MEMORANDUM
FROM
THE DEPARTMENT OF
COMMUNITY DEVELOPMENT

RE: DCI2022-00024 – Gator Recreation

GATOR RECREATION COMPLEX

MASTER CONCEPT PLAN

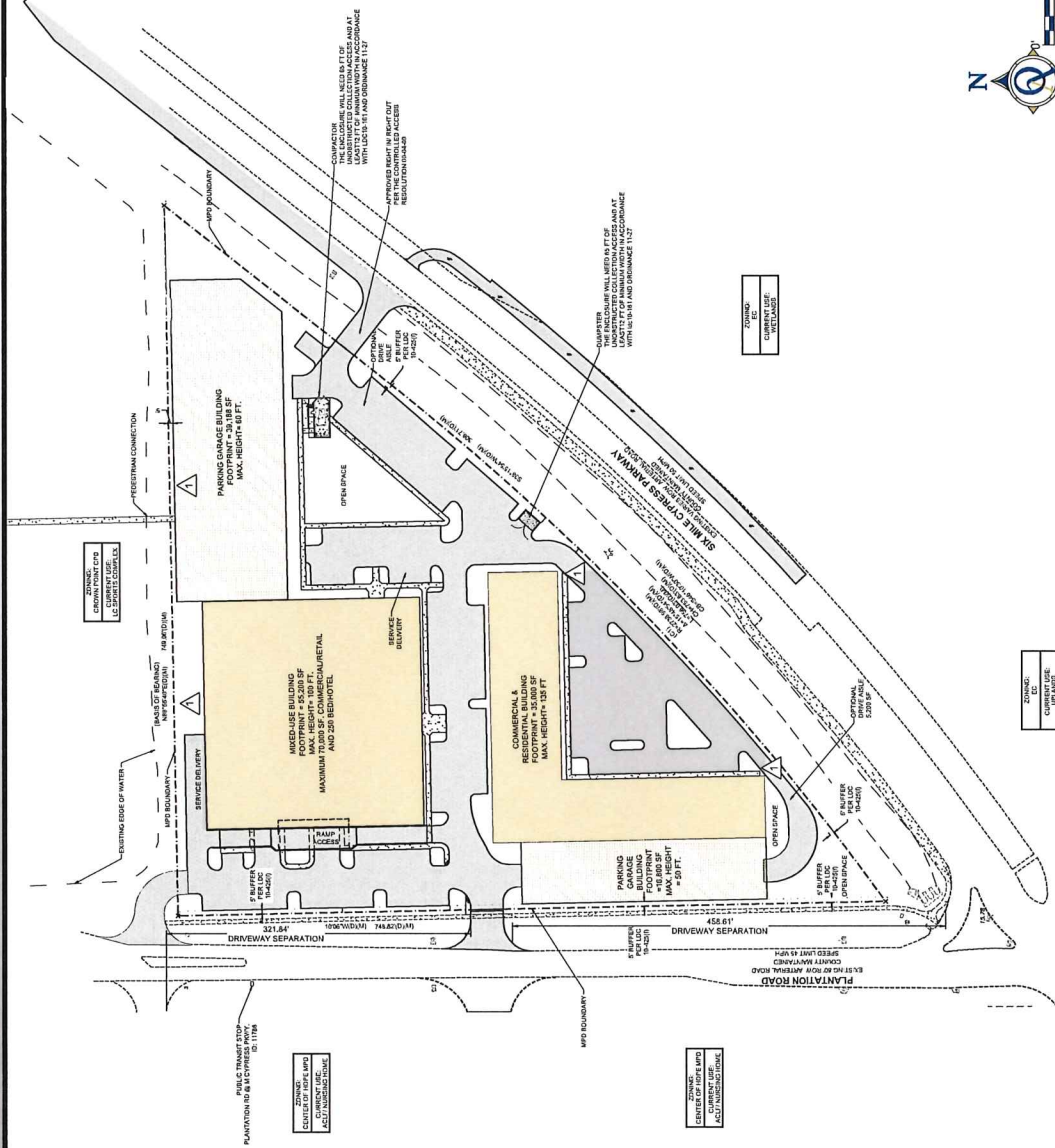
- An optional boardwalk connection to the Century Link Sports Complex (Hammond) Stadium property to the north, contingent upon approval from Lee County Parks and Recreation at time of Local Development Order.

- An additional driveway connection along Plantation Road at the northwest corner, which crosses onto the Century Link Sports Complex (Hammond) Stadium property to align with the existing driveway across Plantation Road serving the Arthrex Distribution Warehouse. This modification is also contingent upon approval from Lee County Parks and Recreation and Lee County DOT.

- The formerly depicted parking garage has been shifted north, set back 5 feet from the north property line (as opposed to 15 feet previously).
- An additional 50-foot-high parking garage has been incorporated into the west side of the L-Shaped building and is set back 5 feet from the Plantation Road right-of-way.

- Modify Condition 5, which addresses the parking garage architectural design standard for the façade facing Ben C Pratt/Six Mile Cypress Parkway, to include the same standard for all three façades of the additional garage that is adjacent to the Plantation Road right-of-way.

- Include Condition 7 requiring approval of applicable Lee County Departments concerning the pedestrian bridge and vehicular access point depicted on the revised Master Concept Plan.

- An update to Condition 1(a) to reflect the revised MCP Date Stamp “Additional Info Dated 05-17-2023”, and incorporation of Project Density language into Condition 1(a) to eliminate former recommended Condition 6 (Project Density).

In addition to the architectural requirements in LDC Sections 10-600 through 10-650, the eastern building façade of the parking garage facing Ben C Pratt/Six Mile Parkway and all building façades of the parking garage adjacent to Plantation Road must provide additional design treatments. Design treatments may include, but are not limited to, a combination of landscaped trellises, opaque covers and permanent landscaping. In addition, surfaces of exposed parking aisles and drives must be finished with specialty pavers or colored stamped concrete having nonreflective, matte surface. Final design of these façades is subject to the Director's discretion, to obscure view of multi-tier parking from the perimeter rights-of-way.

The pedestrian connection and northeast vehicular connection on Plantation Road depicted on the Master Concept Plan are located outside of the perimeter of the subject property and are proposed on property owned by Lee County. At time of local development order the applicant must obtain approval from Lee County Parks and Recreation and Lee County Department of Transportation to incorporate these connection points. Lee County DOT may limit vehicular connection points onto Plantation Road to one in the event an agreement is reached for cross access.

OPEN SPACE EXHIBIT

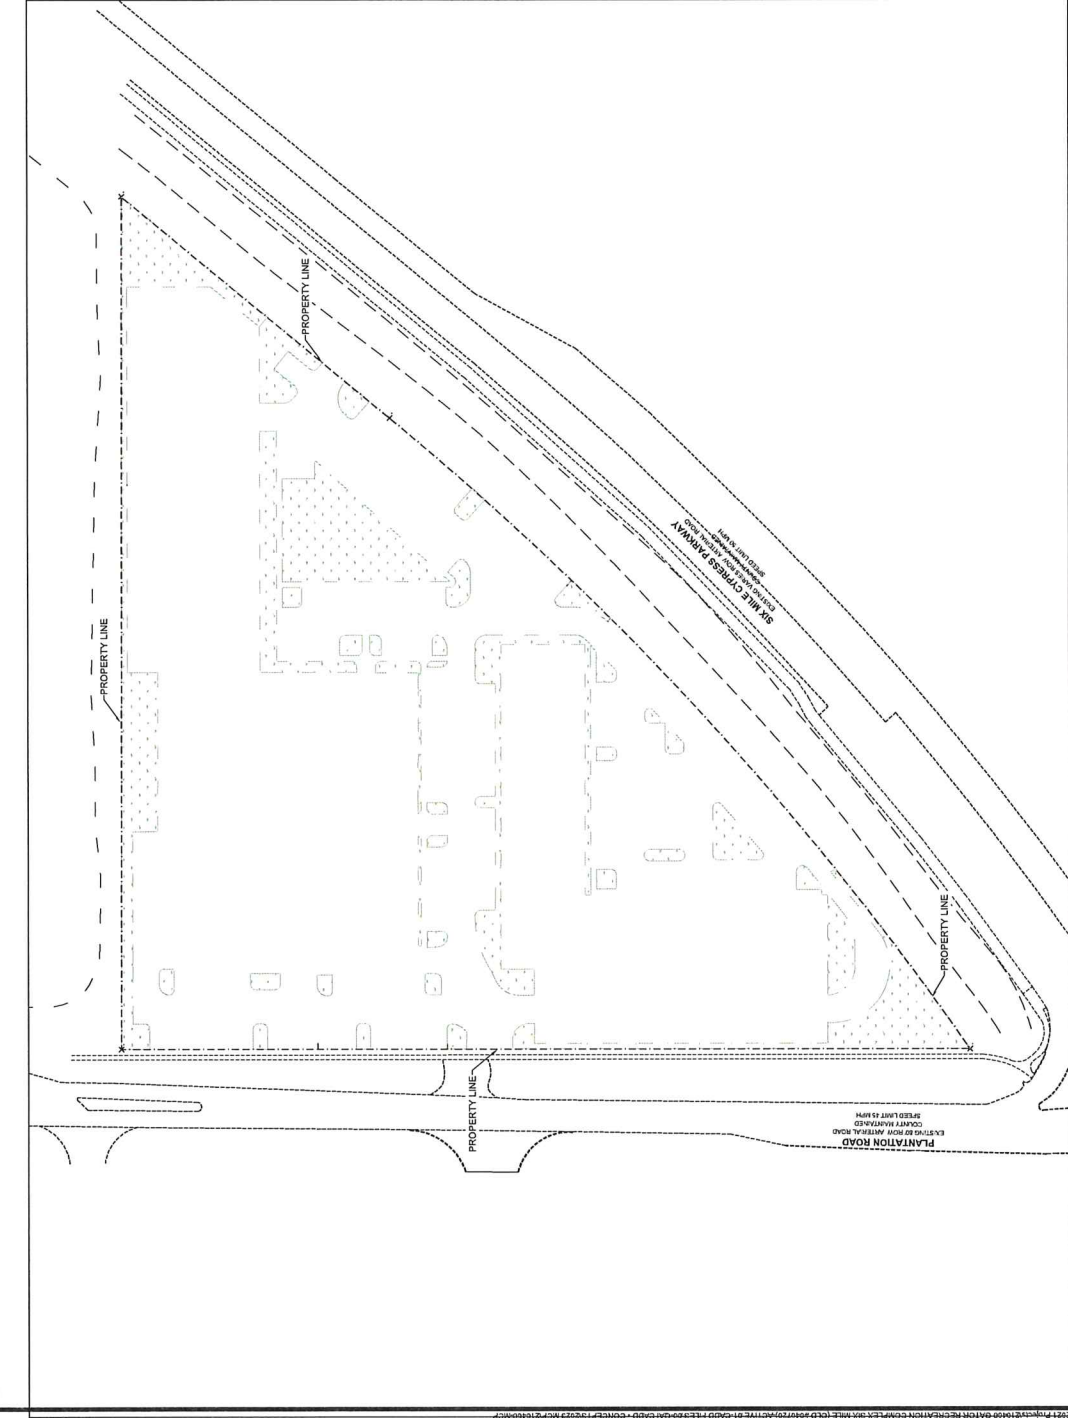
- The Open Space Exhibit has been revised to correspond with revised Master Concept Plan and maintains 20 percent code-required open space.

Prior to local development order approval, the project must depict 20 percent or 1.42 acres of open space in substantial compliance with the MCP.
